# 11.4 Balgreen Road Walk and Cycle Improvements Consultation Summary Report

February 2017

This report summarises the consultation exercise undertaken during the preliminary design stage of walking and cycling improvements to QuietRoute 8 at Balgreen Road and Baird Drive.

Figure 1 Balgreen Road proposals

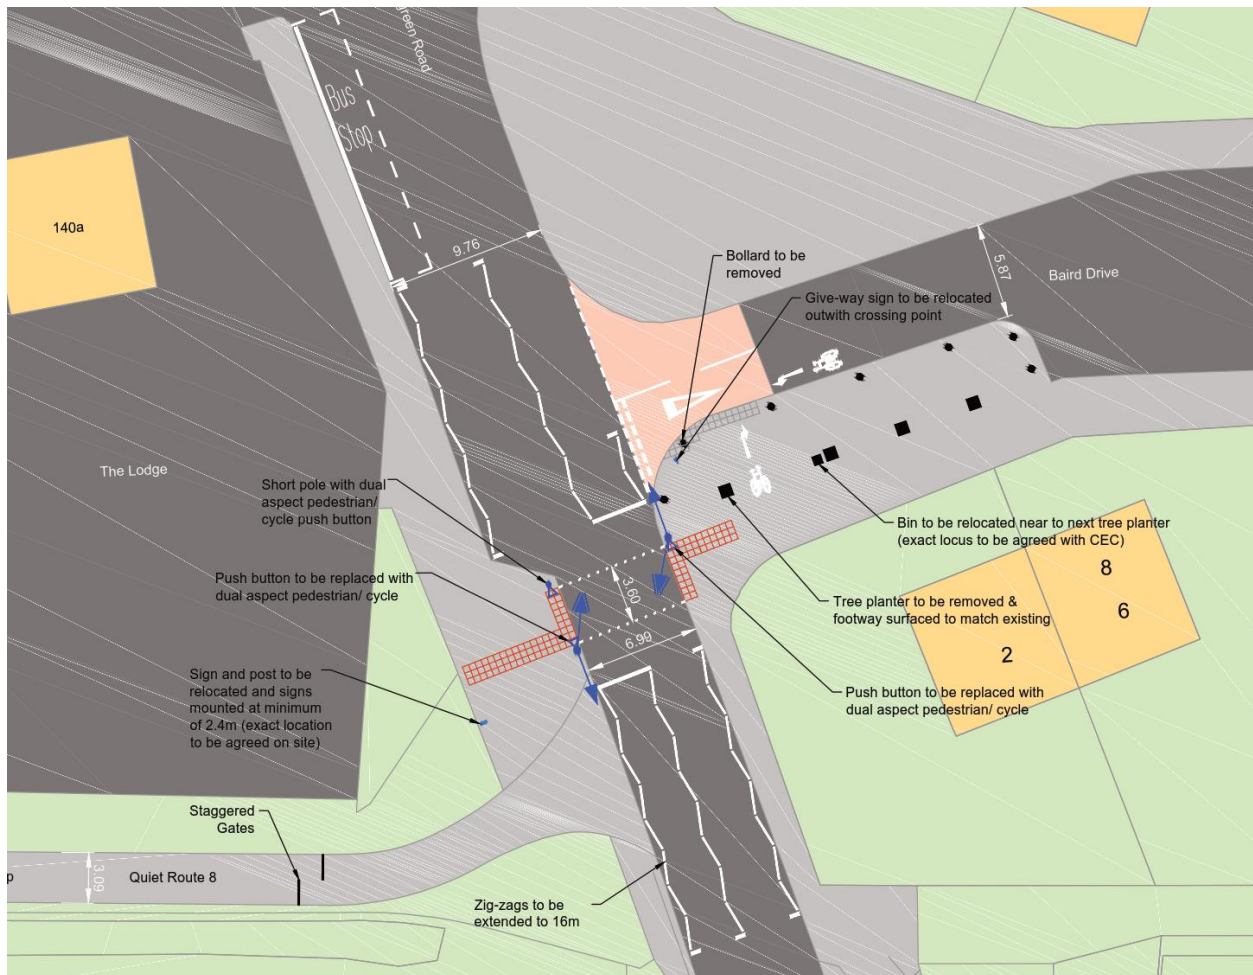
Issue Rank	Issue	No. of Responses
1	Shared use toucan crossing could lead to potential conflict between people walking and cycling.	2
2	Provide greater links to and along Baird Drive for people cycling	2
3	Reduce corner radii	2

Issue Rank	Issue	No. of Responses
1	Provide safe location for people cycling east to join Baird Drive, it is unclear from the current proposals how they would do this.	4
2	Remove the access controls at the bottom of the path to Balgreen Tram stop or replace with bollards.	2
3	Consider wider redesign of Balgreen Road and inclusion into the 20mph scheme.	2

The key issues raised included concerns that a safe facility for people cycling east through the crossing to join Baird Drive. Consultees also said that cycling facilities should be extended along Baird Drive, potentially in the form of a segregated cycleway.

A number of consultees also highlighted that changing to a toucan crossing could lead to potential conflict between people walking and cycling and that some would prefer to see either greater segregation, or clear signage indicating that the area is designated shared use for walking and cycling.

- We shall change the design to bring the pavement entry/exit point on Baird Drive further east, away from the junction. This will make it safer and easier for cyclists to join the crossing from Baird Drive and rejoin the road (Baird Drive) from the pavement.
- We shall include dropped kerbs and shared use re-determination along the widened section of pavement between Saughton Hall Drive and the crossing of Balgreen Road. This shall provide the access that you have highlighted.
